**SERVICE BULLETIN**

**N° 109EP-178**

**ATA 31 – SLIDING SCREEN INSTALLATION**

The purpose of this Service Bulletin is to install the sliding glare shield on the instrument panel shield hood Assy.

**Figure 1**

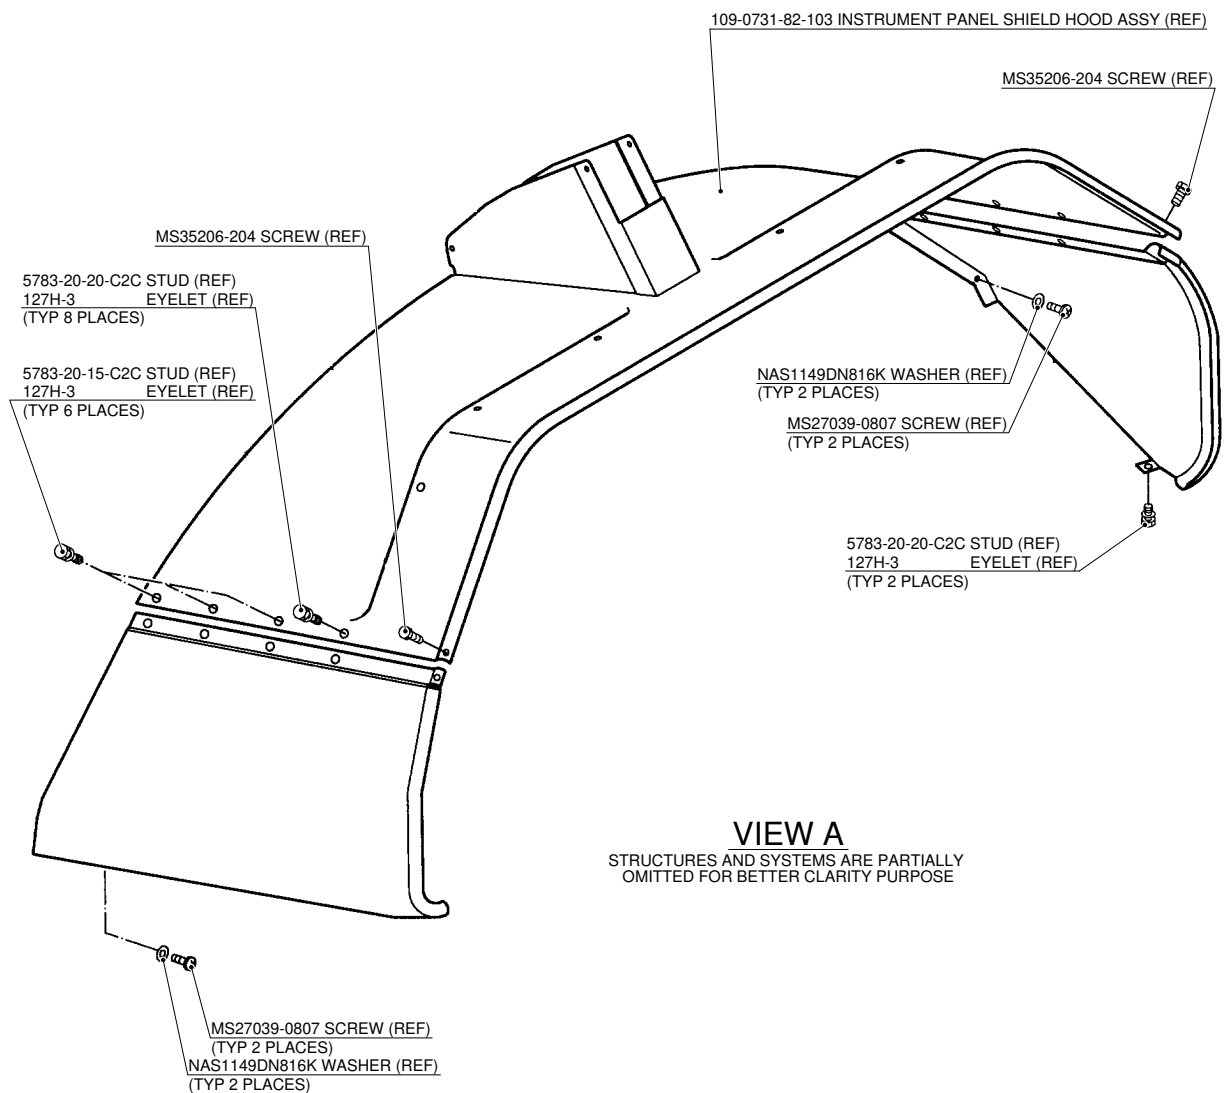
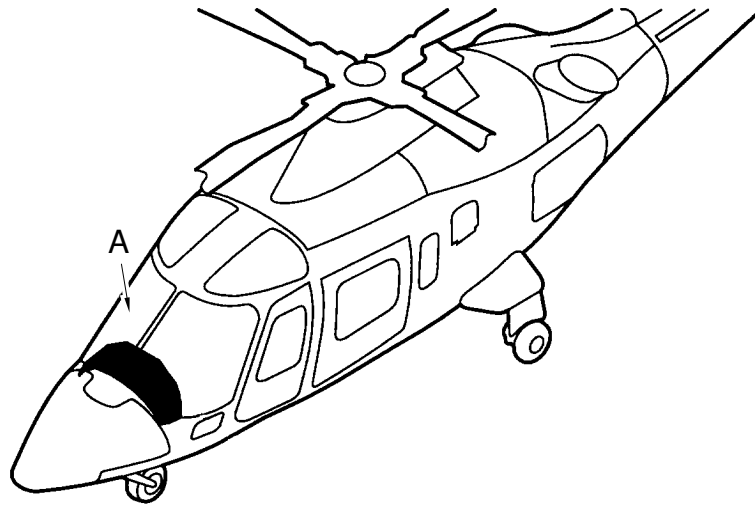
3. In accordance with MM Paragraph 31-11-6 and with reference to Figure 1, remove the instrument panel shield hood assy and the related hardware. Retain for later re-use.

**Figure 2**

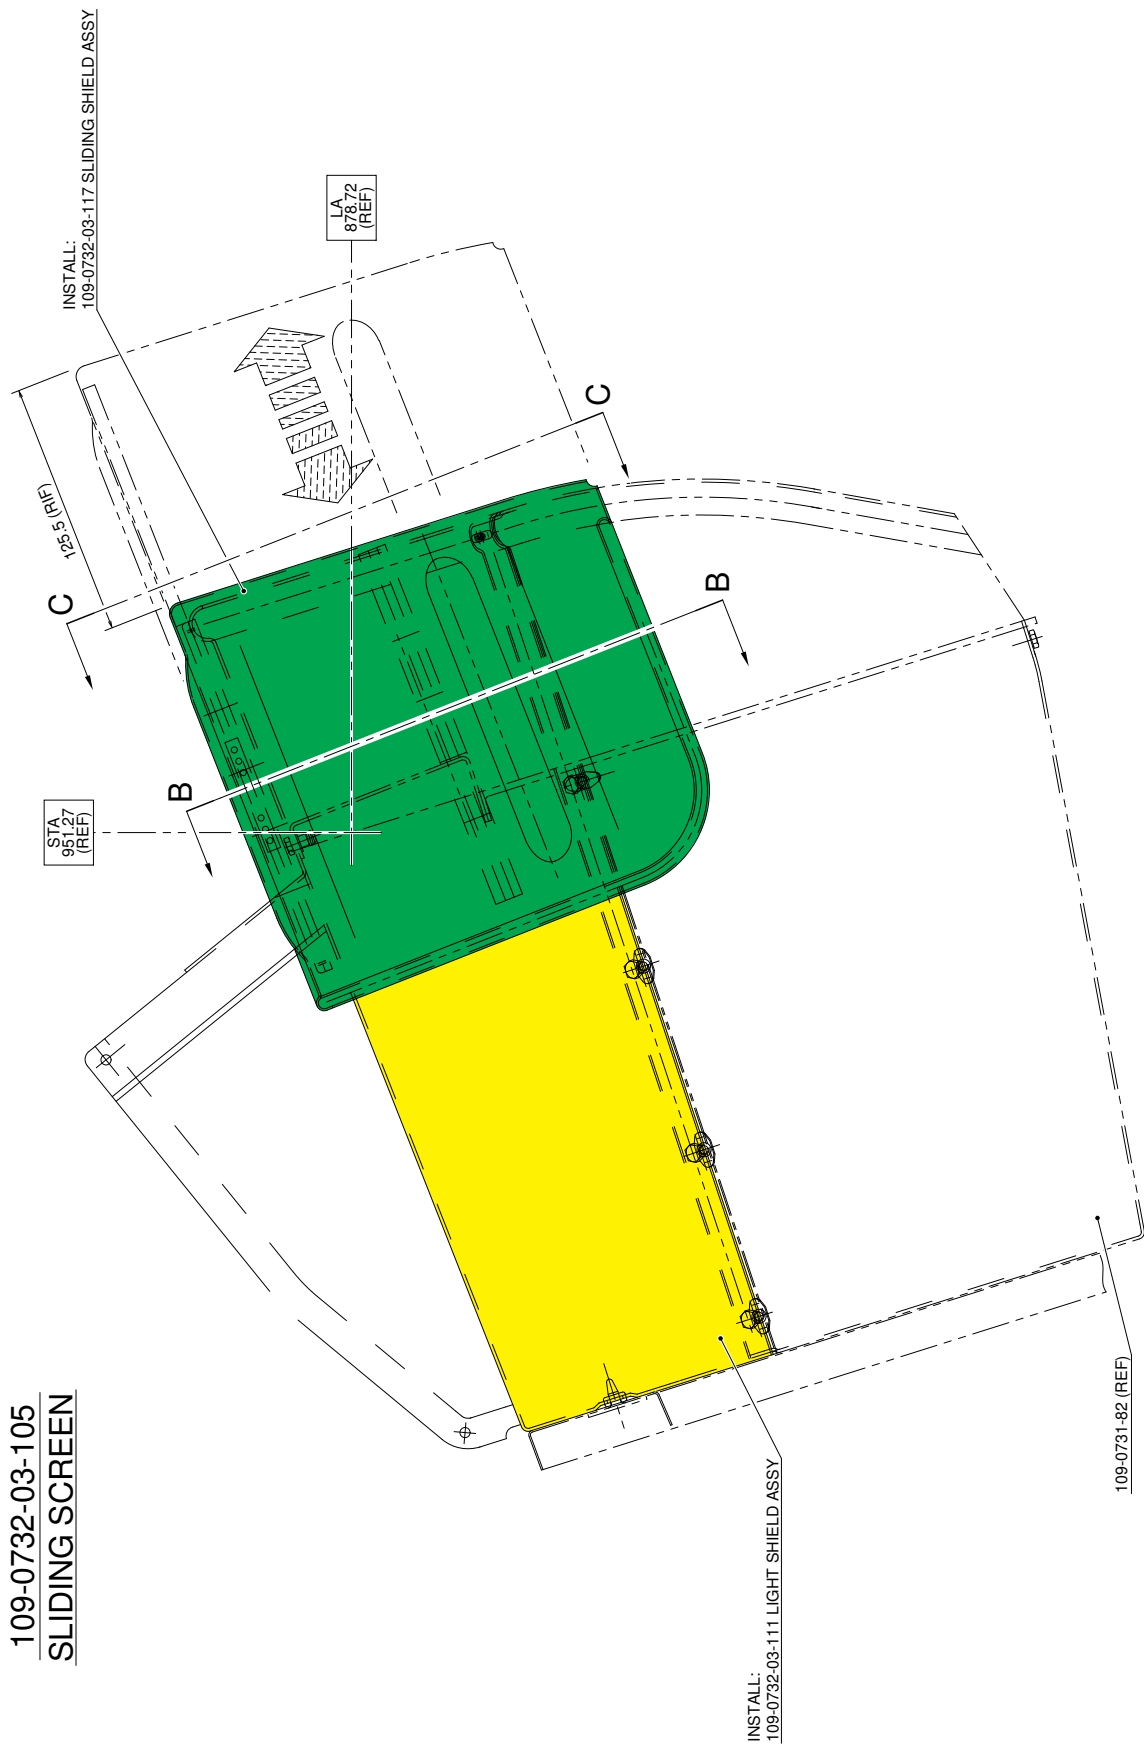
- 5.11 With reference Figure 4, mark the light shield assy with P/N 109-0732-03-111.
6. In accordance with MM Paragraph 31-11-6 and with reference to Figures 1 and 2, re-install the light shield assy with P/N 109-0732-03-111 by means of the previously removed hardware (Ref step 3).

8. With reference to Figure 3, install n°2 guides P/N 109-0320-65-105 on the light shield assy with P/N 109-0732-03-111.
  9. With reference to Figure 2 and 3, install the sliding shield assy P/N 109-0732-03-117 and n°4 shims P/N 109-0732-03-131 by means of n°4 screws P/N MS24693-S28, n°4 screws P/N LN65022-0410 and n°4 washers P/N LN9025-0410K on the light shield assy with P/N 109-0732-03-111.

Figure 3

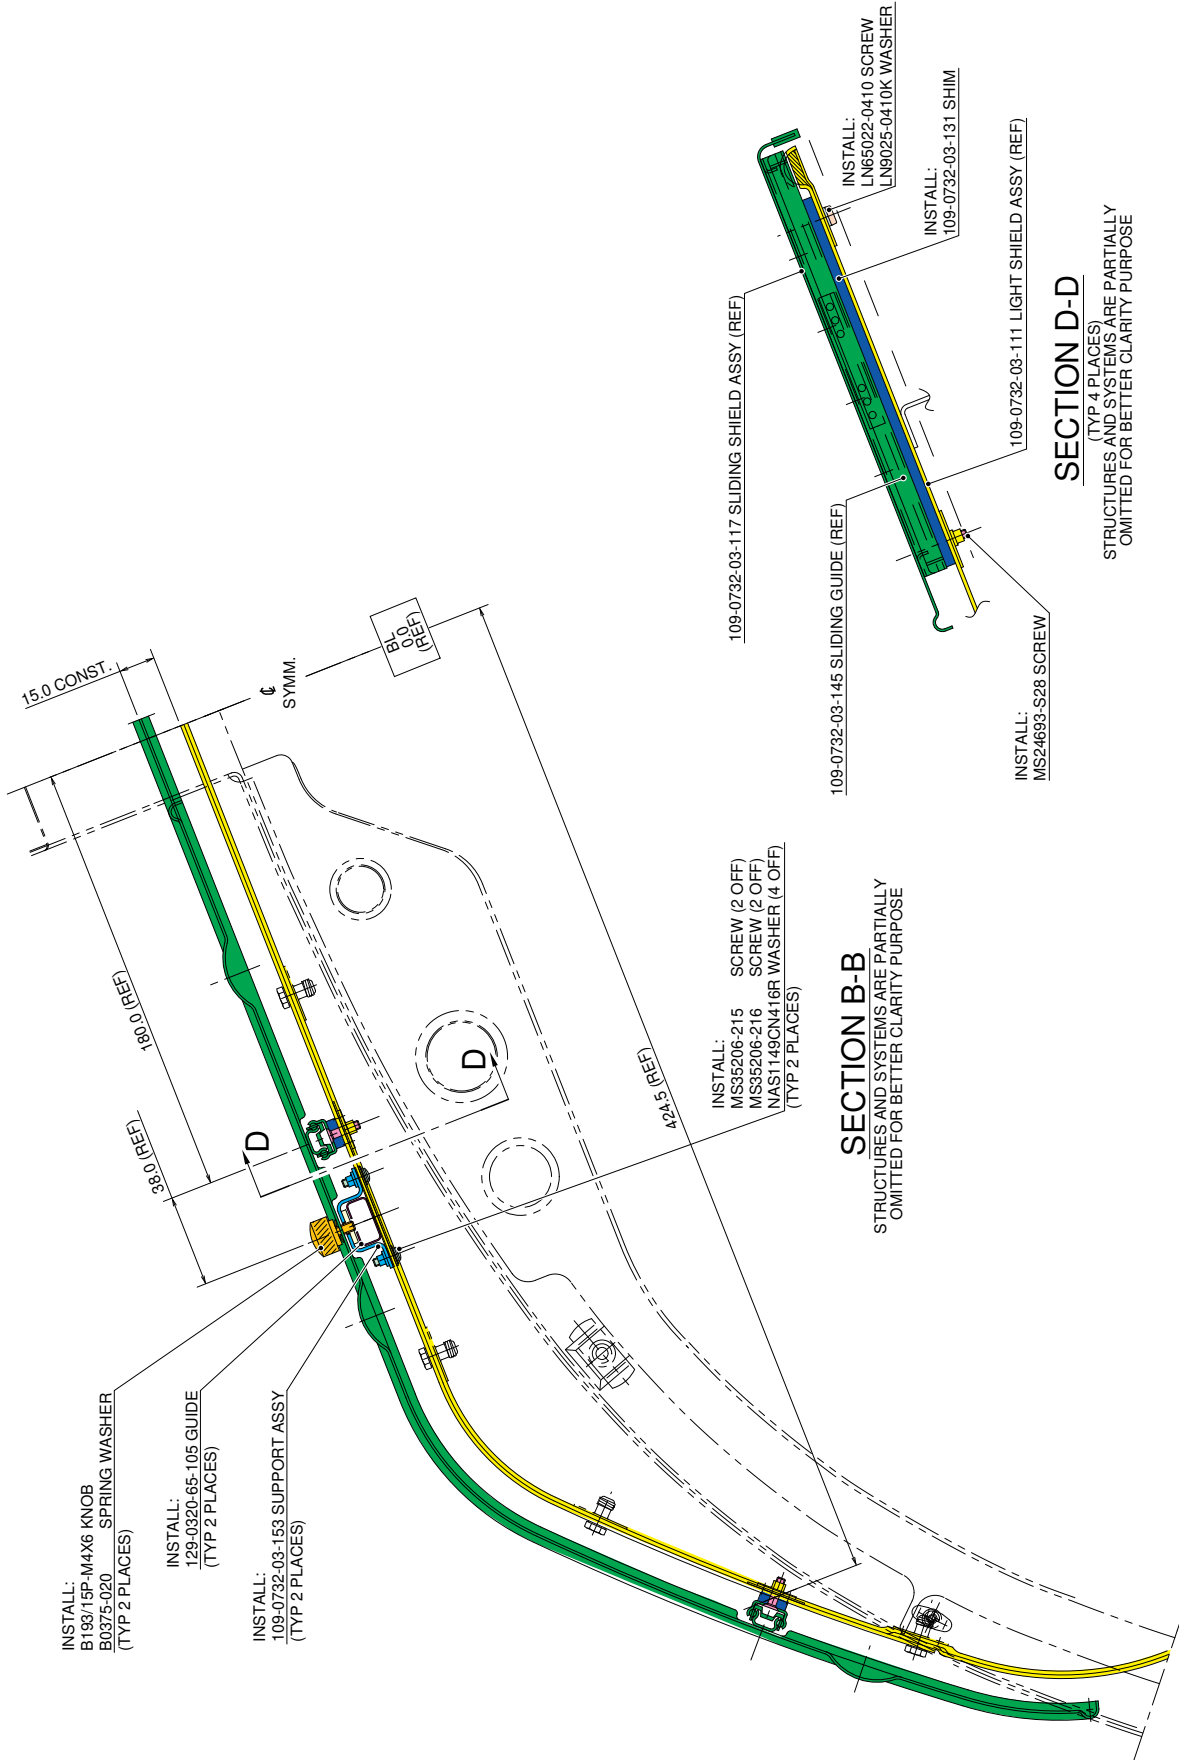
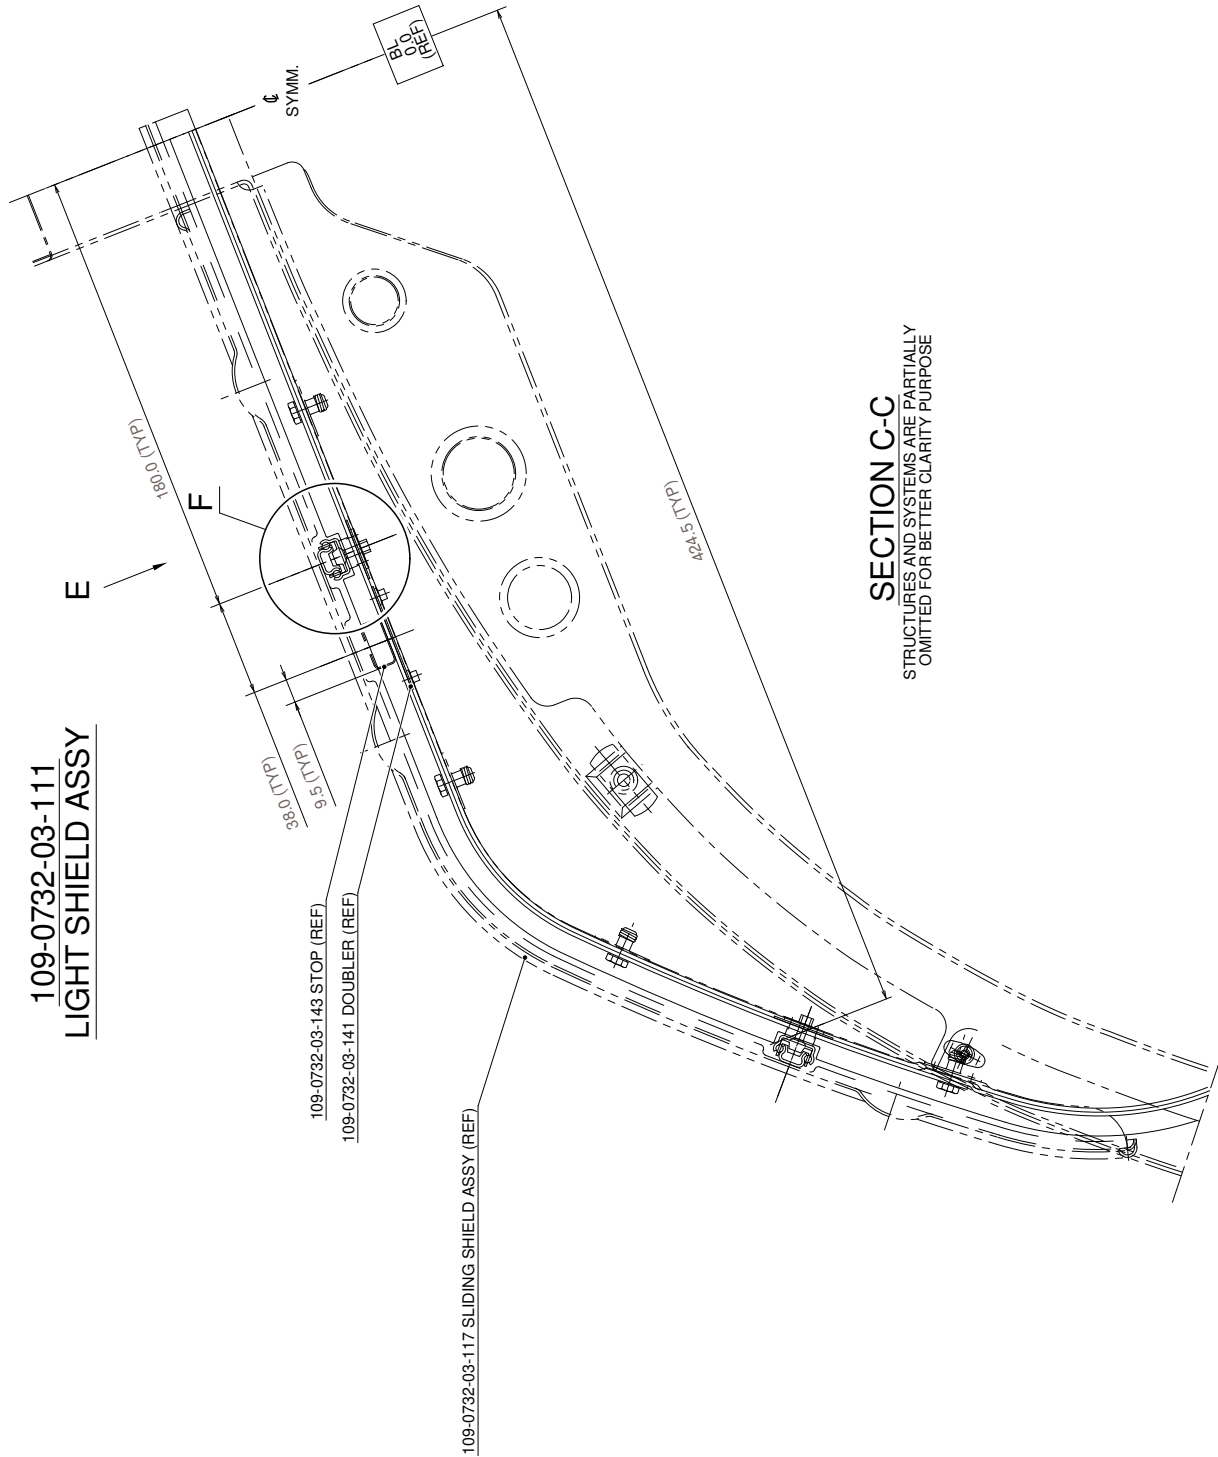
7. With reference to Figure 3, install n°2 support assemblies P/N 109-0732-03-153 by means of n°4 screws P/N MS35206-215, n°8 screws P/N MS35206-216 and n°12 washers P/N NAS1149CN416R on the light shield assy with P/N 109-0732-03-111.

10. With reference to Figure 3, install n°2 knobs P/N B193/15P-M4X6 and n°2 spring washers P/N B0375-020 in the indicated positions.
11. In accordance with MM Paragraph 06-40-1, re-install all external panels, internal panels and internal liners previously removed.
12. In accordance with weight and balance changes, update the Chart A (see Rotorcraft Flight Manual, Part II, section 6).
13. Return the helicopter to flight configuration and record for compliance with this Service Bulletin on the helicopter logbook.
14. Send the attached compliance form to the following mail box:

**Figure 4**

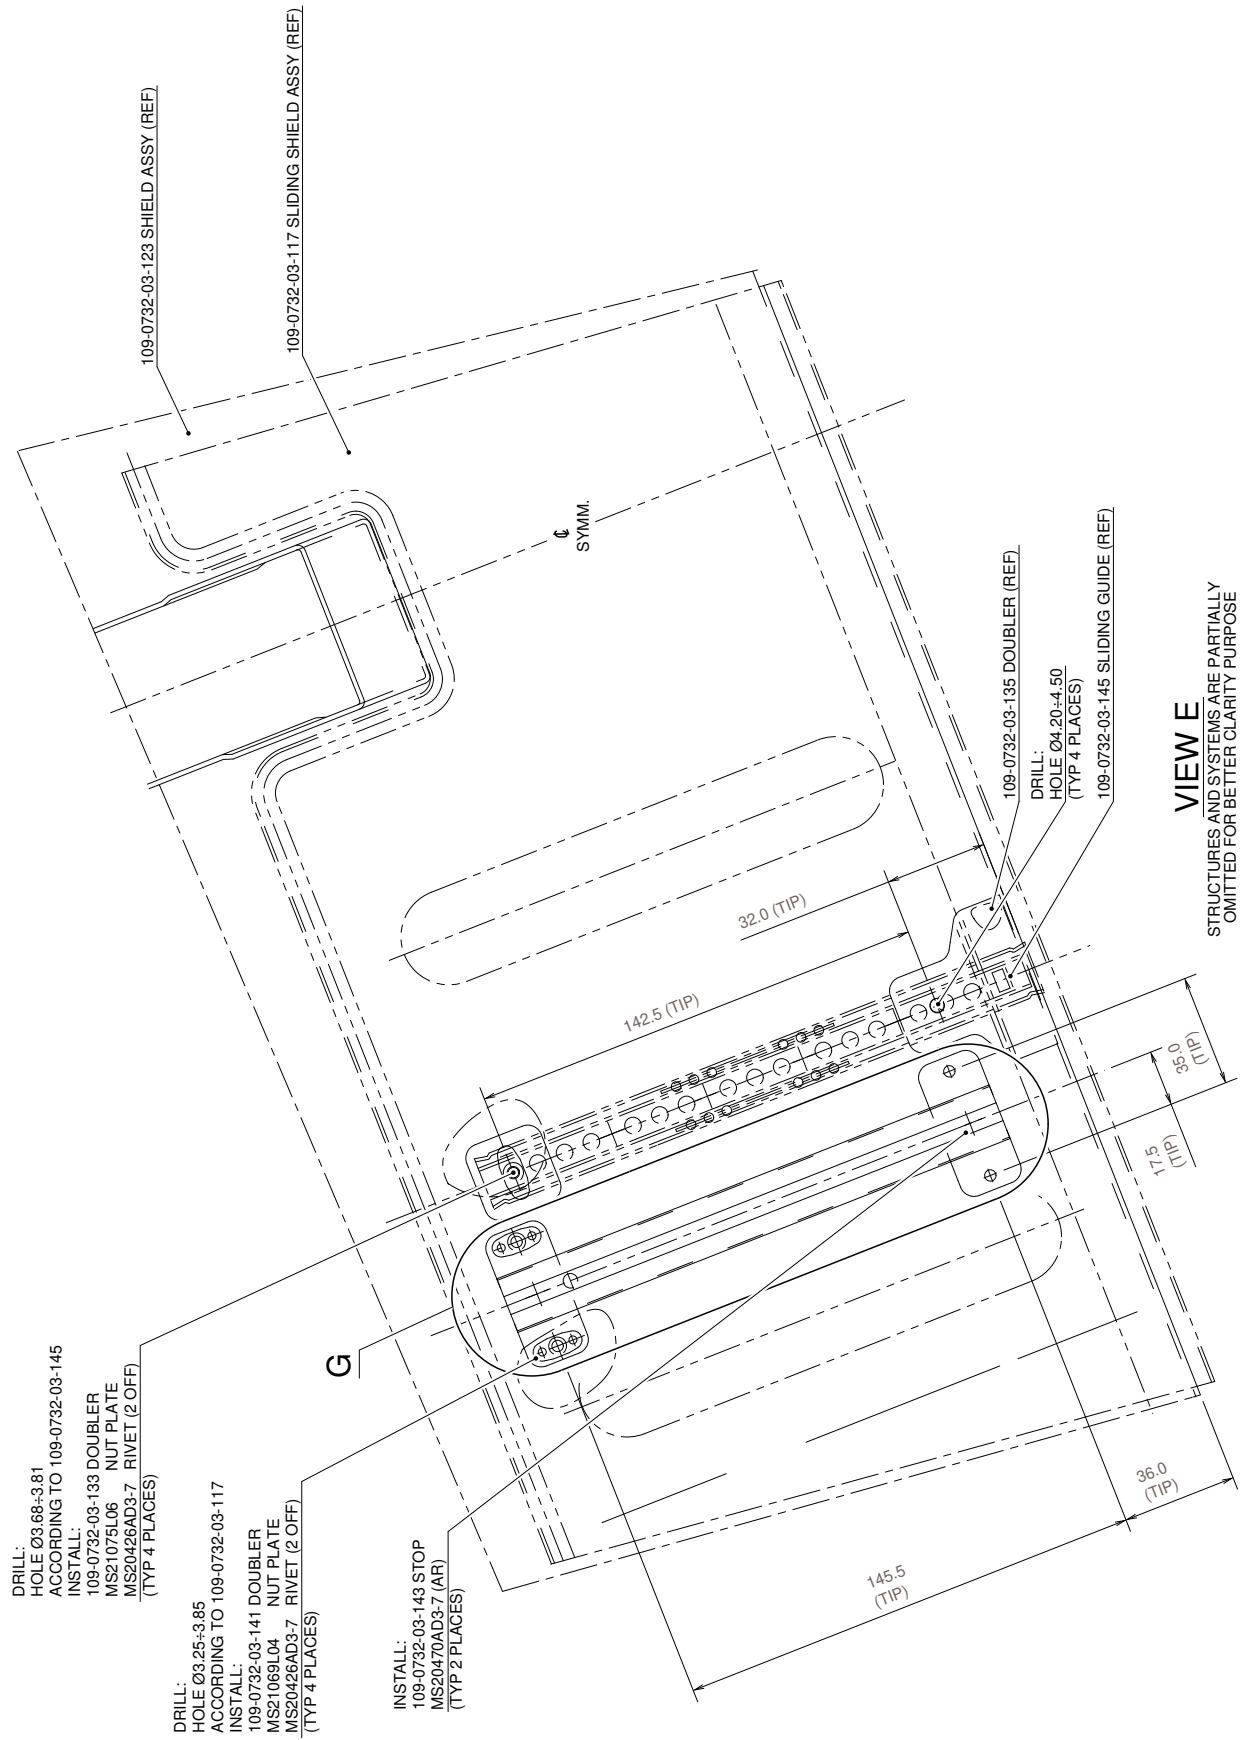
- 4.3 With reference Figure 7, mark the sliding shield assy with P/N 109-0732-03-117.
5. With reference to Figures 4 thru 6, assemble the light shield assy P/N 109-0732-03-111 as described in the following procedure:
- 5.1 With reference to Figure 6 Detail F, install the filler P/N 109-0732-03-147 by means of adhesive AF163-2U.03 (C275) on the shield assy P/N 109-0732-03-123.
- 5.2 With reference to Figure 6 Detail F, rework the shield assy P/N 109-0732-03-123 as indicated in n°4 places according to the position of the sliding guides P/N 109-0732-03-145 installed on the shield assy P/N 109-0732-03-117.
- 5.3 With reference to Figure 6 Detail F, apply adhesive EA934.NA (C054) on the edges of the filler P/N 109-0732-03-147. Smooth with abrasive paper and touch up with the same colour of the shield assy P/N 109-0732-03-123.
